Project	IEEE 802.16 Broadband Wireless Access Working Group < http://ieee802.org/16 >	
Title	Architecture clarification and Coexistence Protocol messages cleaning	
Date Submitted	2005-09-09	
Source(s)	Chi-Chen Lee, Hung-Lin Chou, Industrial Technology Research Institute, Computer and Communications Research Labs, Taiwan Bldg. 11, 195 Sec. 4, Chung Hsing Rd. Chutung, HsinChu, Taiwan 310, R.O.C.	Voice: +886-3-5914579 Fax: +886-3-5829733 mailto: jjlee@itri.org.tw
Re:	Call for Contributions: IEEE 802.16 License-Exempt Task Group, IEEE 802.16h-05/018	
Abstract	Propose the architecture of storage of identification information and Coexistence Protocol.	
Purpose	Information.	
Notice	This document has been prepared to assist IEEE 802.16. It is offered as a basis for discussion and is not binding on the contributing individual(s) or organization(s). The material in this document is subject to change in form and content after further study. The contributor(s) reserve(s) the right to add, amend or withdraw material contained herein.

Architecture clarification and Coexistence Protocol

[Figure 14. Classification of 802.16 LE network architecture](#)

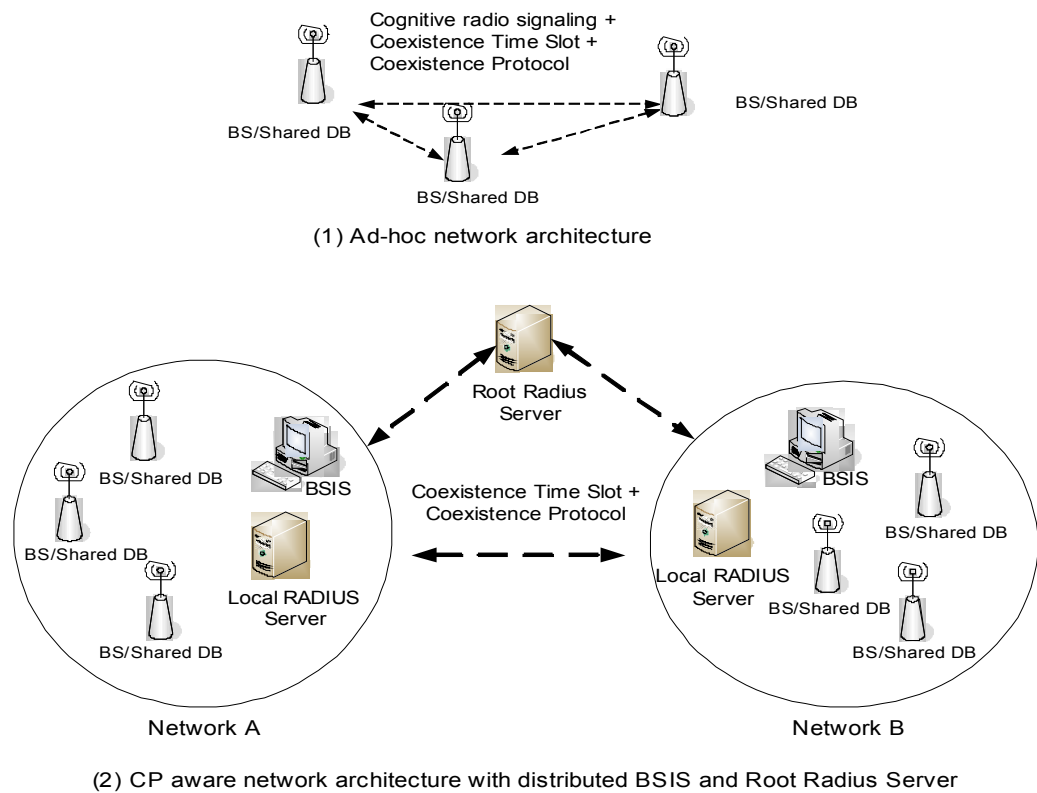
[Change Figure 14 as following]

[Figure 14 shows the classification of IEEE 802.16 LE inter-network communication architecture:](#)

Figure 12. Initialization procedures — BS

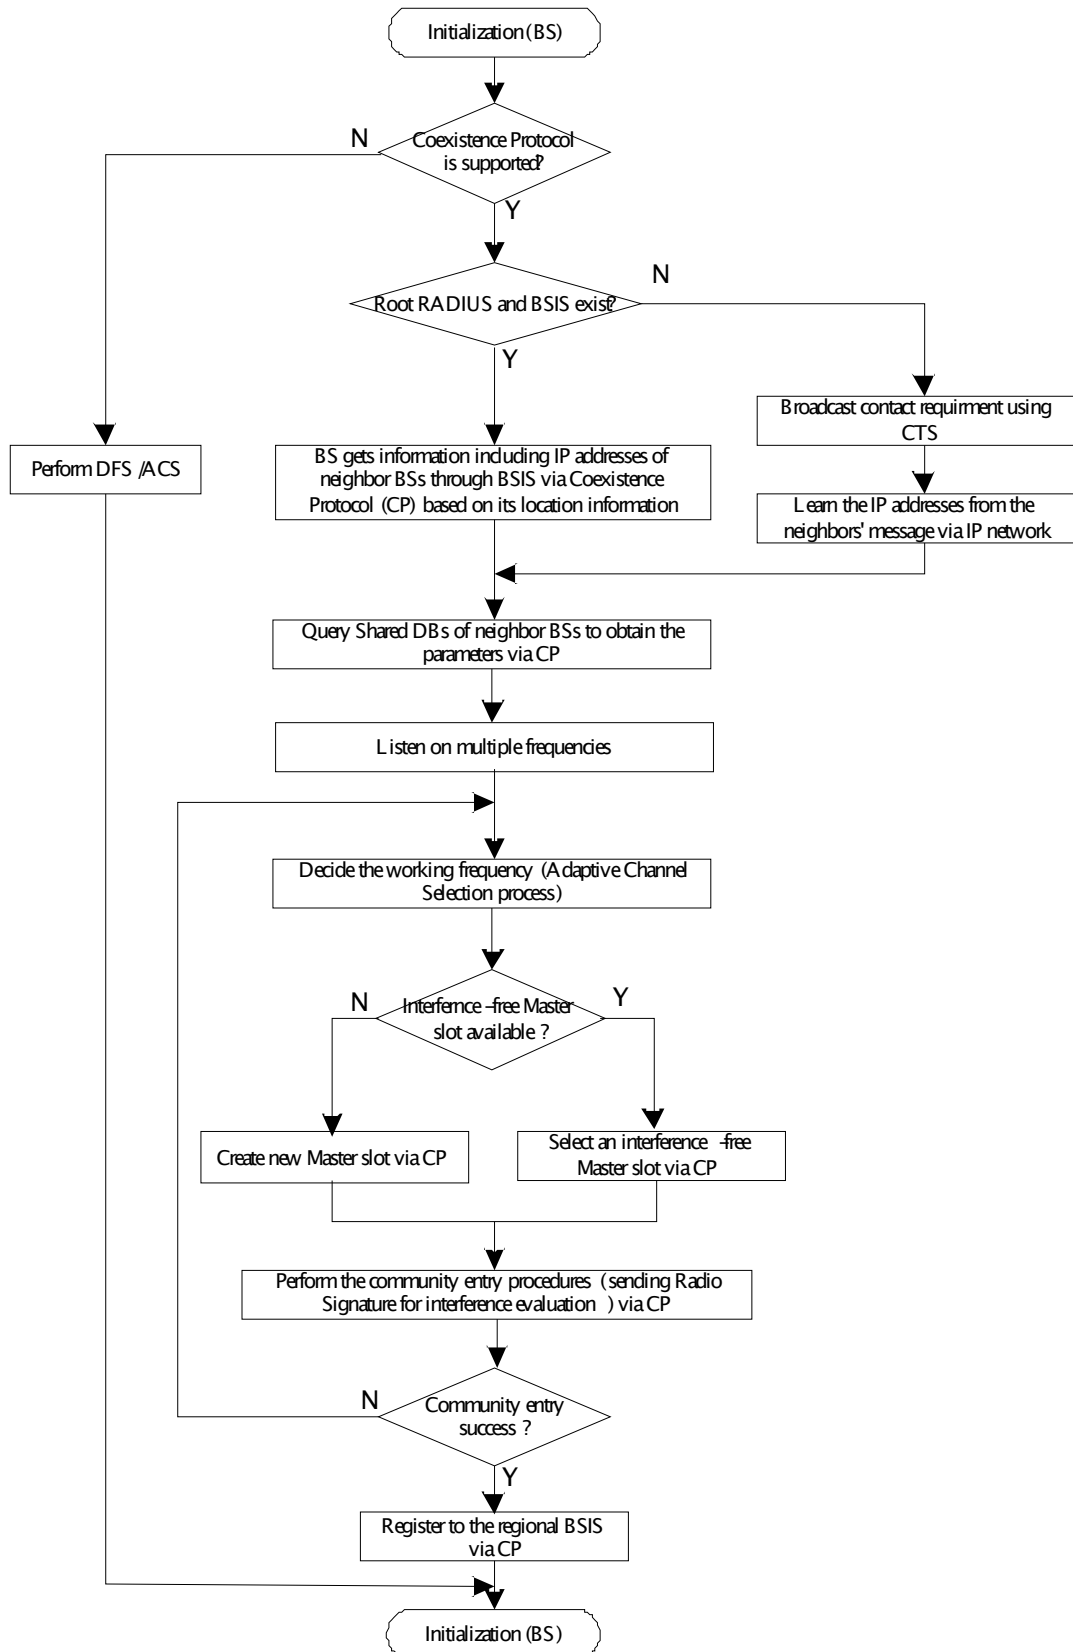
[Replace Figure 12 as following]
